## Access Compliance Report Public Rights-of-Way (Curb Ramps)

Intersection ID: 30423 Main Street: OLD\_PINEVILLE\_RD Cross Street: PINEVILLE\_POINT\_AV Location: NW
ADA ID: 7809D323173B Ramp Type: PerpDiag Initial Pass/Fail: Fail Overall Compliance: No Severity Score: 10

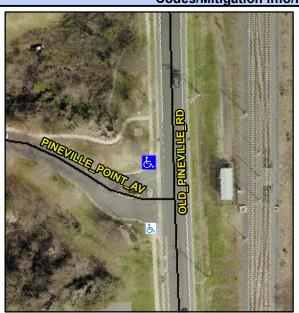
R304.5.1, R304.5.3

Remove & Replace Curb Ramp With Two New Directional Ramps or Equivalent.
